**GOVERNMENT/INDUSTRY AERONAUTICAL CHARTING FORUM
INSTRUMENT PROCEDURES GROUP
Meeting 03-02 Silver Spring, MD
October 20, 2003**

**AERONAUTICAL CHARTING FORUM
INSTRUMENT PROCEDURES GROUP
OPEN AGENDA ITEMS FROM MEETING 03-02**

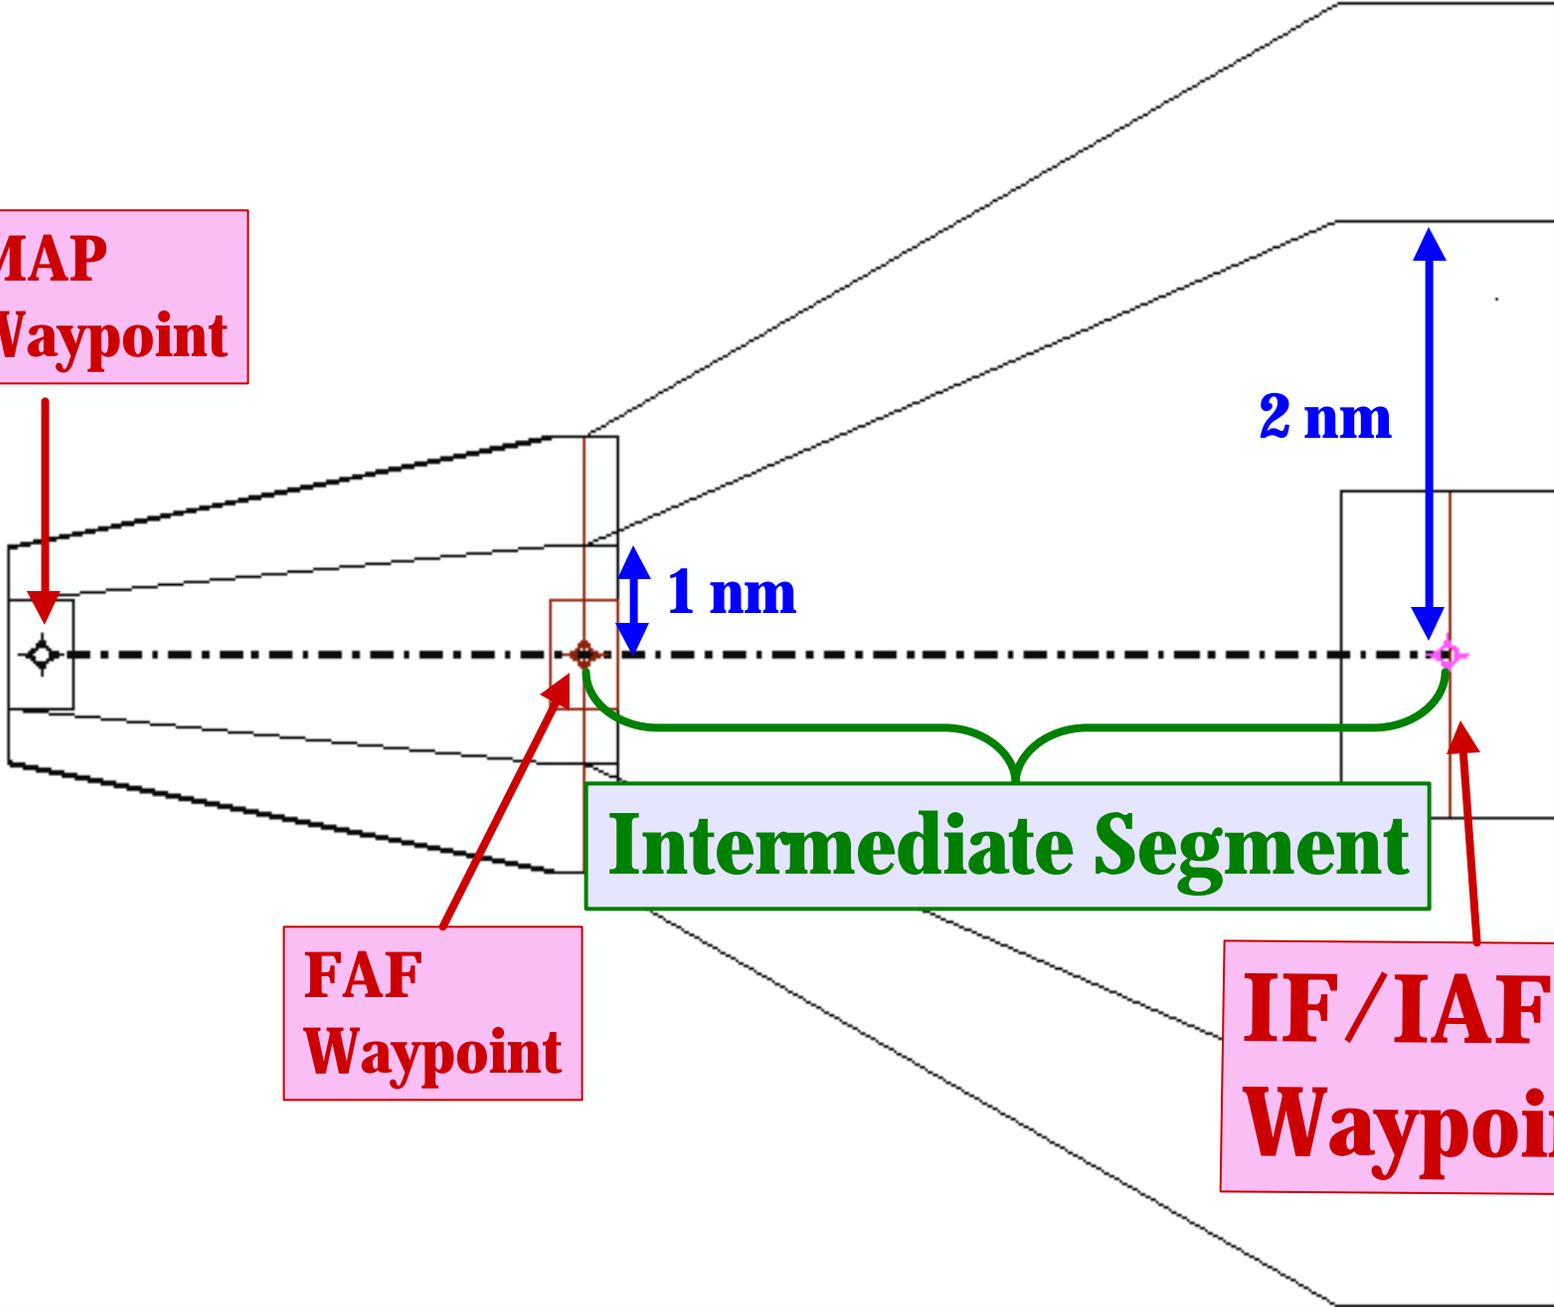
Is "CENTR" an Intermediate Fix, or an IAF?

3.	<p>The .65 diagram contained in 7110.326 should change or add another diagram including an example with “CENTR” being an IF. (Steve Bergner (NBAA) I brought a similar recommendation to ACF 03-01 in graphical form suggesting a diagram and example with “CENTR” having a HIL depicted.</p>	Unresolved.

RNAV (GPS) RWY 17 ORLANDO INTL (MCO)

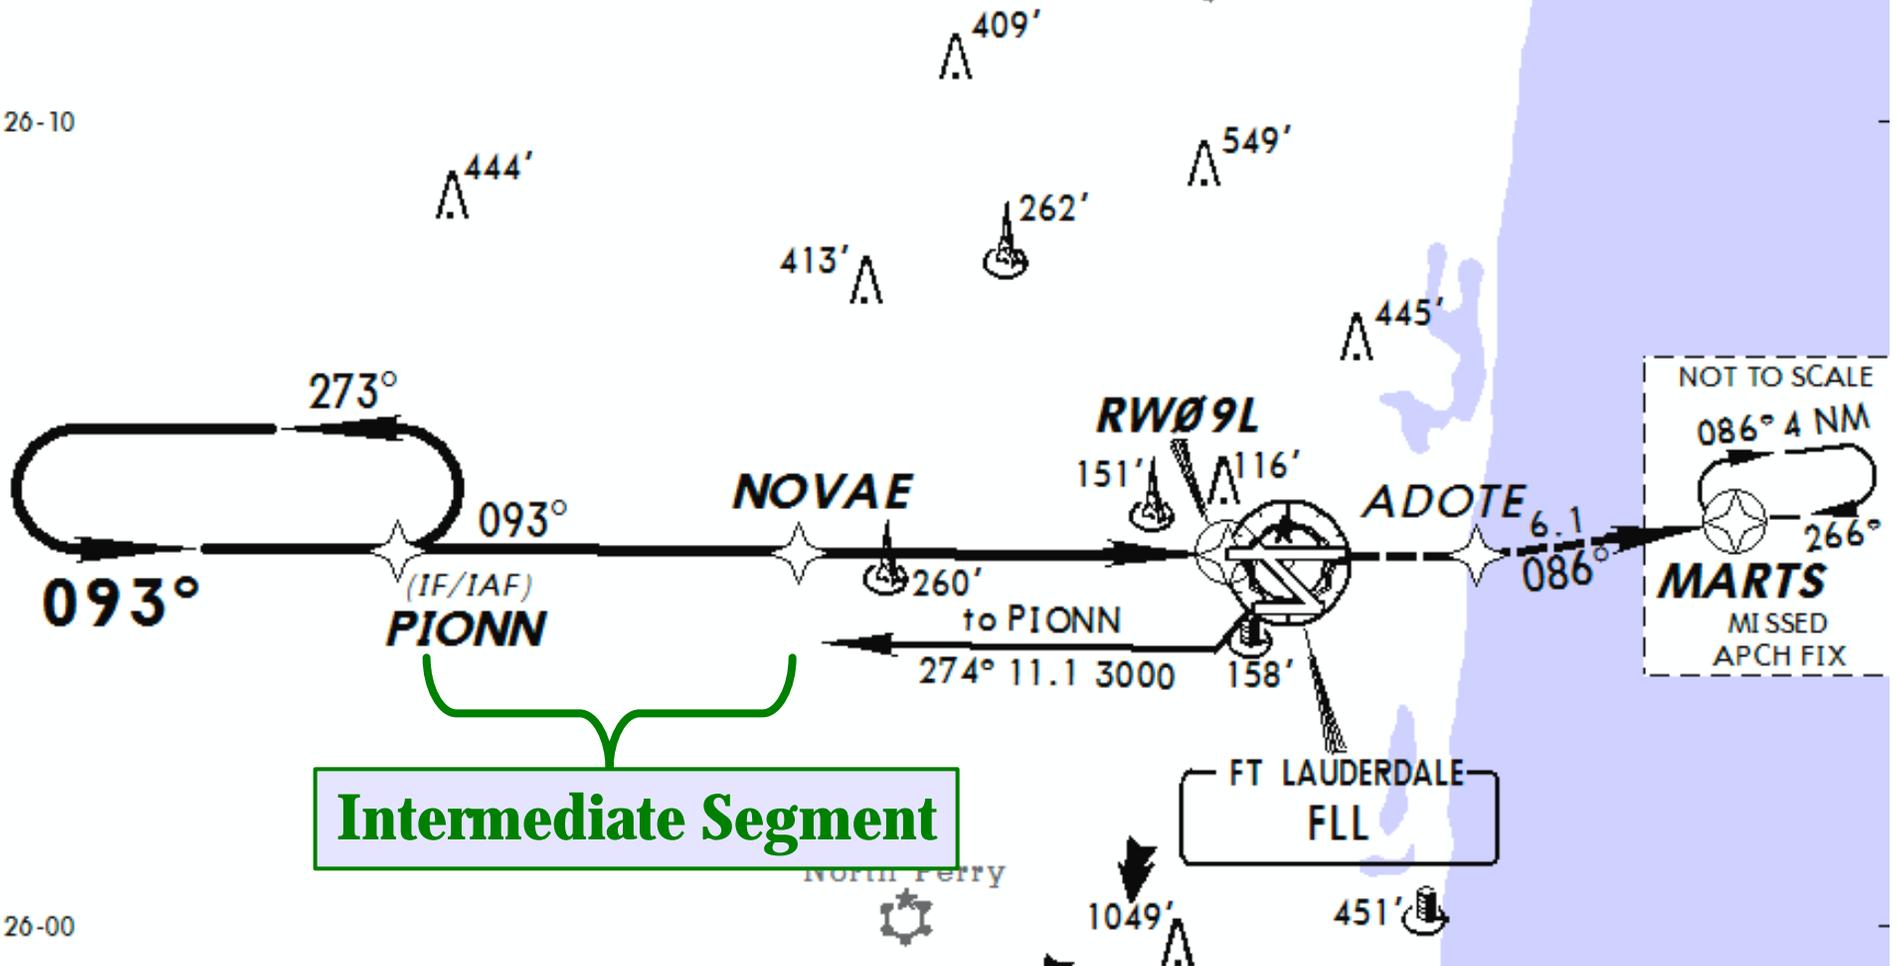
Is "PIONN" an Intermediate Fix, or an IAF?

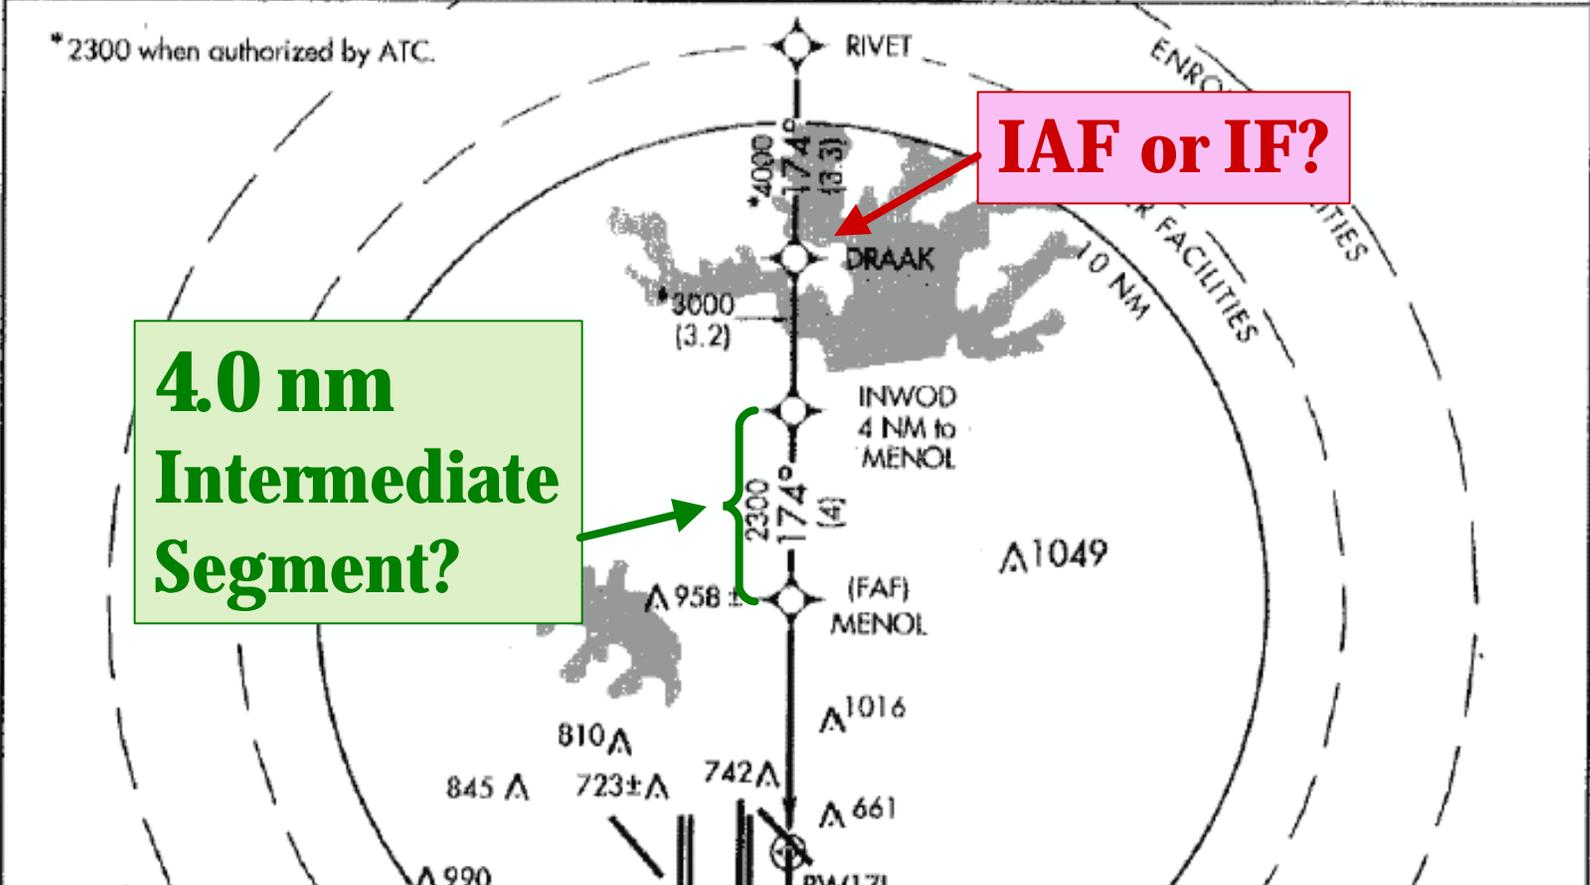
**4.0 nm
Intermediate
Segment?**

IAF or IF?

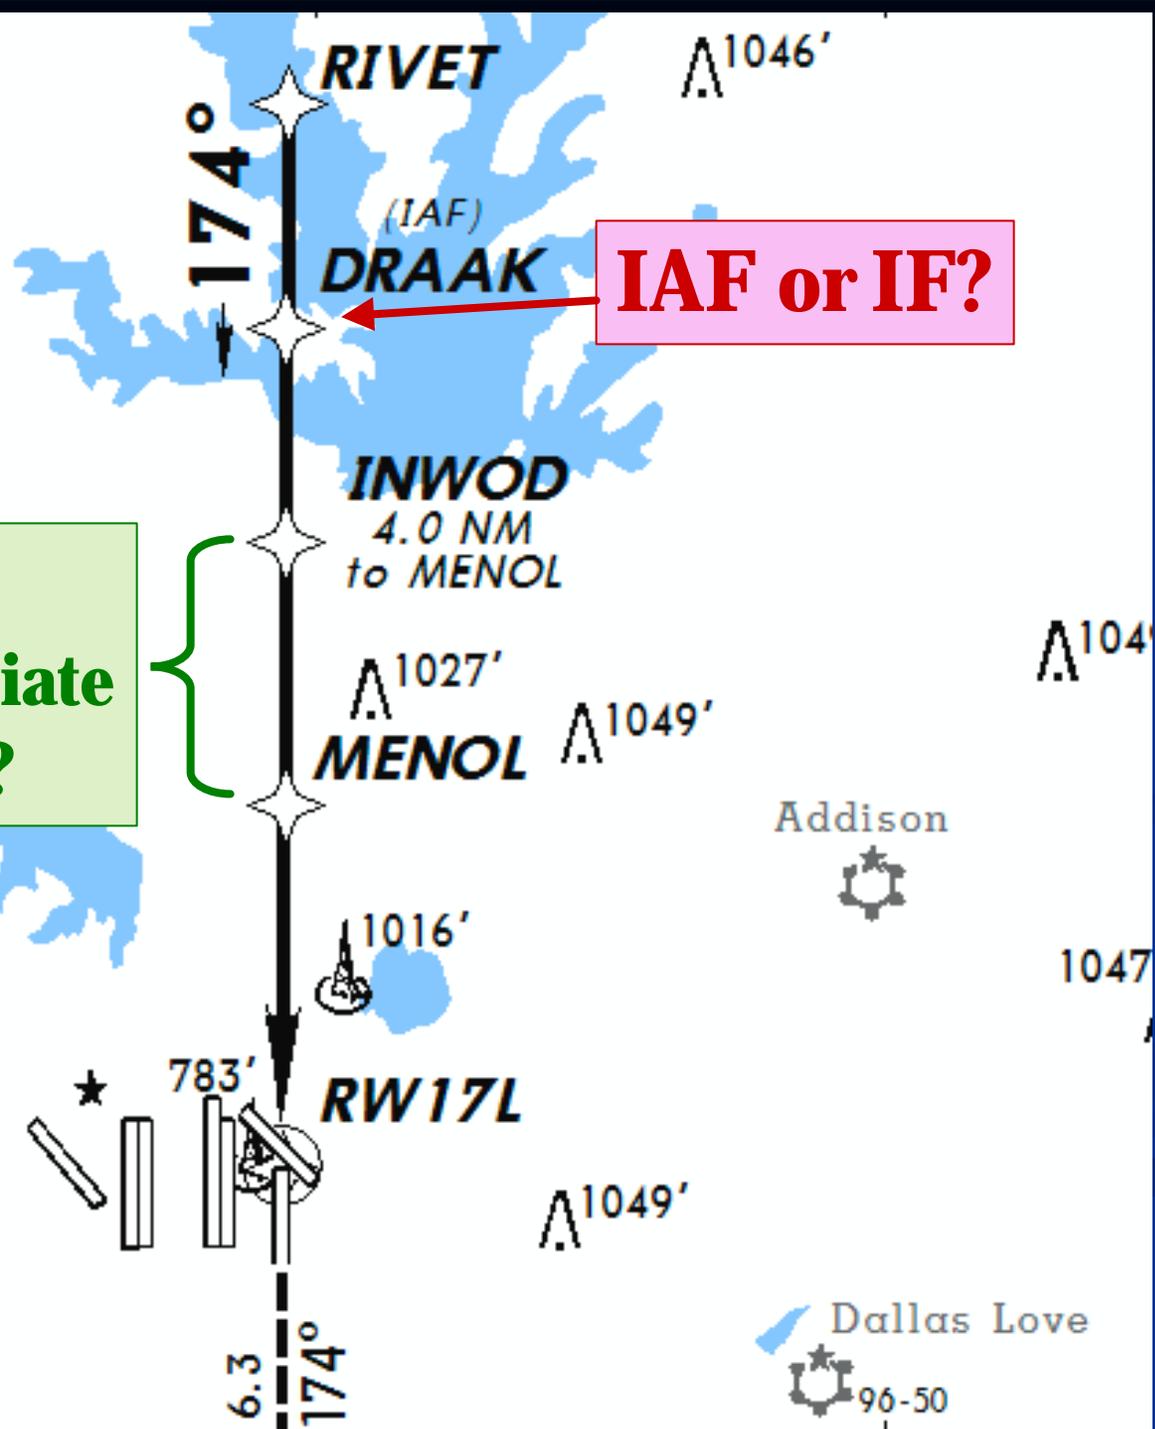
**4.0 nm
Intermediate
Segment?**

IAF or IF?
